**TOWN OF LOS GATOS
PLANNING COMMISSION AGENDA
JULY 24, 2024
110 EAST MAIN STREET
TOWN COUNCIL CHAMBERS
7:00 PM**

3. Requesting Approval for Modification of Planned Development Ordinance 1412, Subdivision of One Lot into Two Lots, Construction of a Single-Family Residence, and Site Work Requiring a Grading Permit on Property Zoned O:PD. **Located at 120 Oak Meadow Drive.** APN 529-10-131. Subdivision Application M-20-011, Planned Development Application PD-20-002, Architecture and Site Application S-22-021. Categorically Exempt Pursuant to CEQA Guidelines Sections 15315: Minor Land Divisions; 15303: New Construction; and 15304: Minor Alterations to Land. Property Owner: Marty and Penny McFarland. Applicants: Terence J. Szewczyk (M-20-011 and PD-20-002) and Jay Plett, Architect (S-22-021). Project Planner: Sean Mullin.

DATE: July 19, 2024
TO: Planning Commission
FROM: Joel Paulson, Community Development Director
SUBJECT: Requesting Approval for Modification of Planned Development Ordinance 1412, Subdivision of One Lot into Two Lots, Construction of a Single-Family Residence, and Site Work Requiring a Grading Permit on Property Zoned O:PD. **Located at 120 Oak Meadow Drive.** APN 5

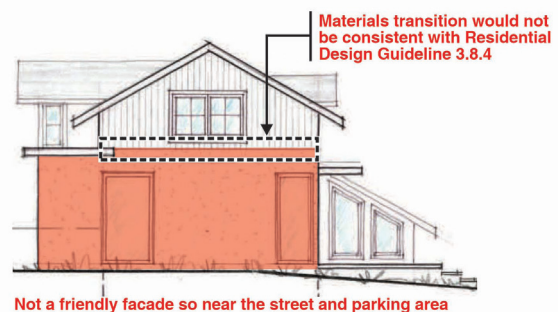
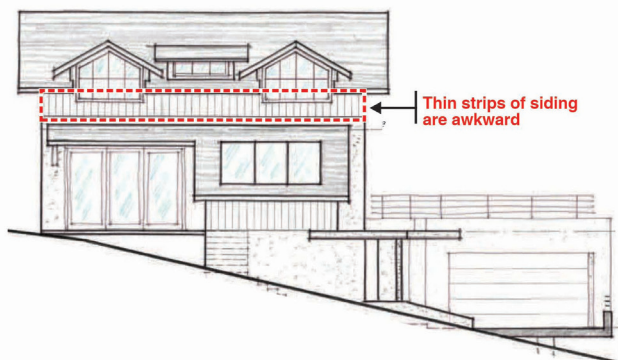
Large amount of stucco would be out of character with this neighborhood and not consistent with Residential Design Guideline 3.8.2

2. The small areas of wood siding on the front and rear elevations is awkward, and the materials change in the same plane which would not be consistent with Residential Design Guideline 3.8.4.

RECOMMENDATIONS

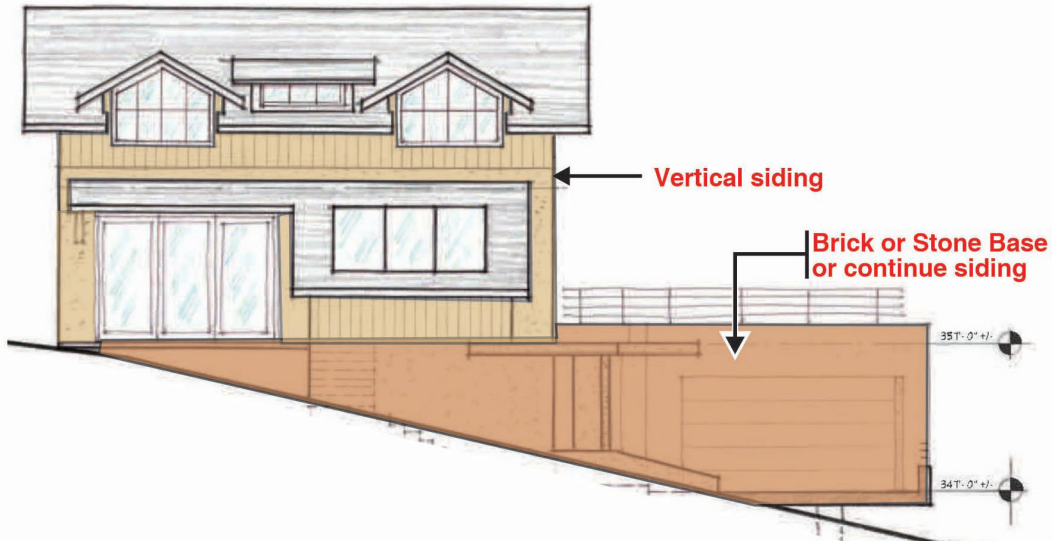
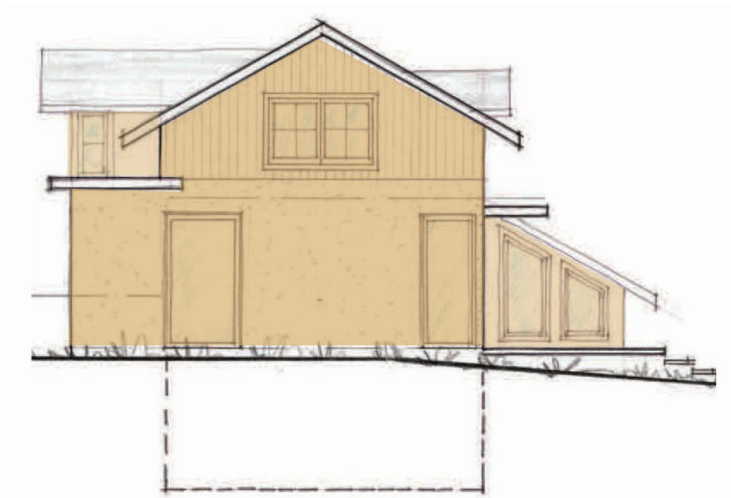
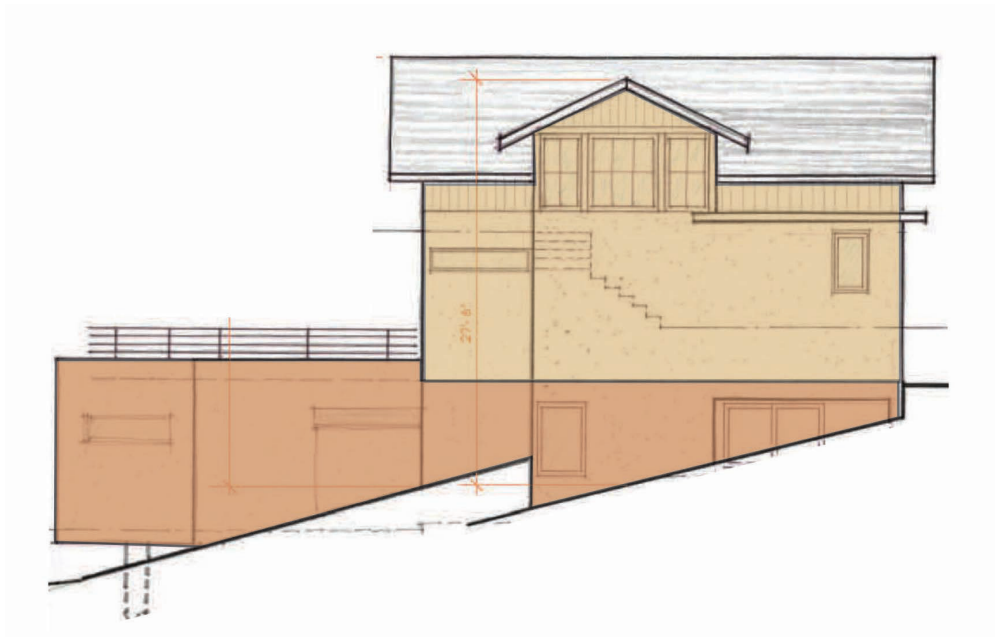
1. Reduce the large amount of stucco on the house by extending the vertical siding consistently down to the first floor line. **See prior response.**
2. Use brick or stone for the building base below the first floor line or continue the use of vertical siding in this area. The adjacent existing home on this larger parcel has a prominent brick base - see photo below. If brick or stone is used, provide a projecting brick or stone ledge at the transition with any vertical siding. If vertical siding is used, add a horizontal belly band to break up taller wall planes. **Horizontal belly band is not appropriate for this home. If we were transitioning from one wood above and another type of wood below, then a belly band might be appropriate, but ours is not the case. In this case, a belly band is not warranted or desirable.**

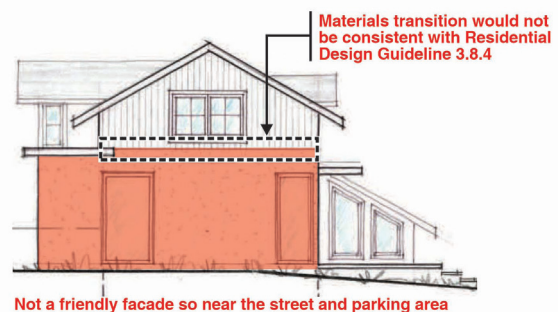
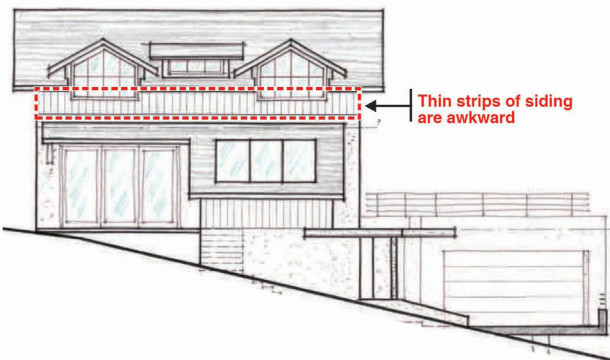
Large amount of stucco would be out of character with this neighborhood and not consistent with Residential Design Guideline 3.8.2

2. The small areas of wood siding on the front and rear elevations is awkward, and the materials change in the same plane which would not be consistent with Residential Design Guideline 3.8.4.

RECOMMENDATIONS

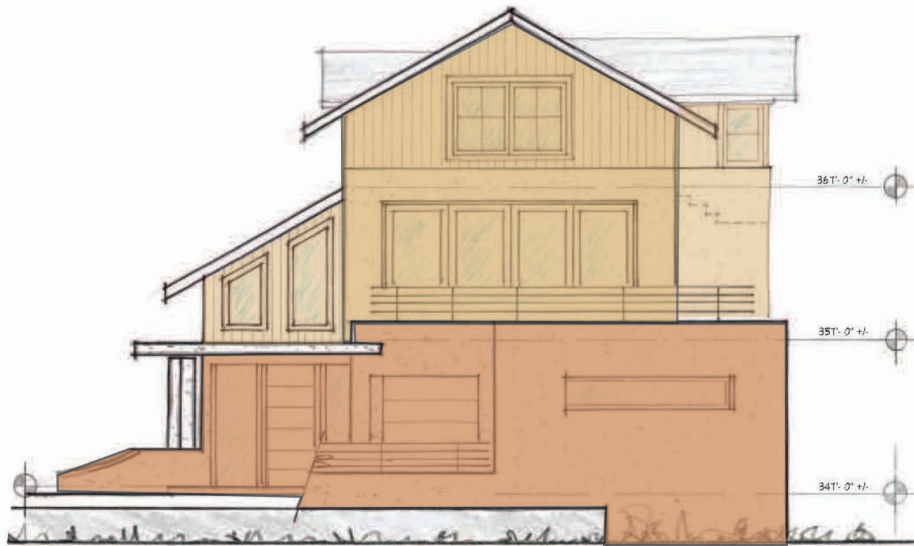
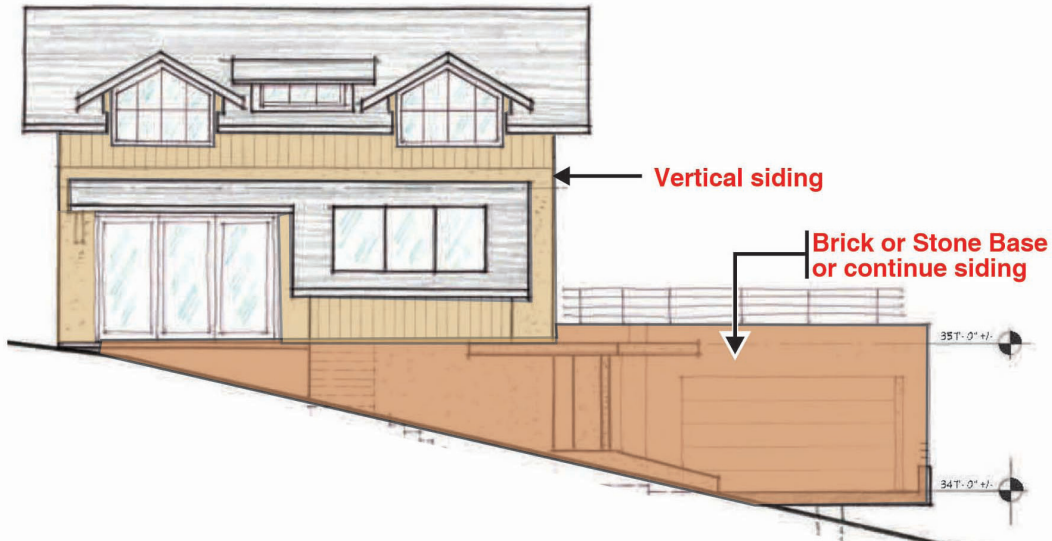
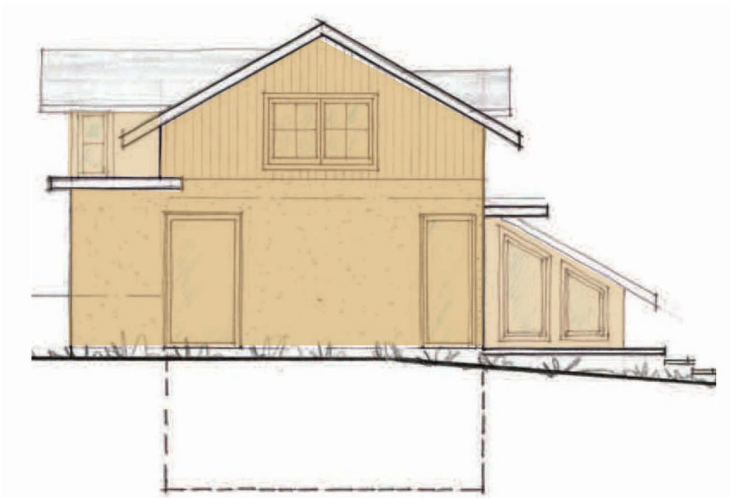
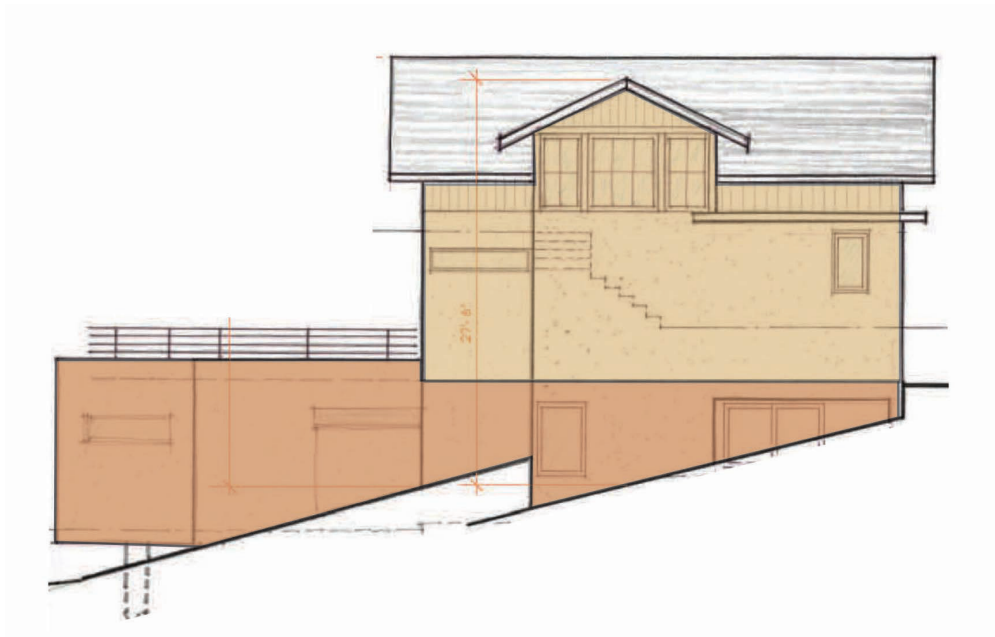
1. Reduce the large amount of stucco on the house by extending the vertical siding consistently down to the first floor line. **See prior response.**
2. Use brick or stone for the building base below the first floor line or continue the use of vertical siding in this area. The adjacent existing home on this larger parcel has a prominent brick base - see photo below. If brick or stone is used, provide a projecting brick or stone ledge at the transition with any vertical siding. If vertical siding is used, add a horizontal belly band to break up taller wall planes. **Horizontal belly band is not appropriate for this home. If we were transitioning from one wood above and another type of wood below, then a belly band might be appropriate, but ours is not the case. In this case, a belly band is not warranted or desirable.**
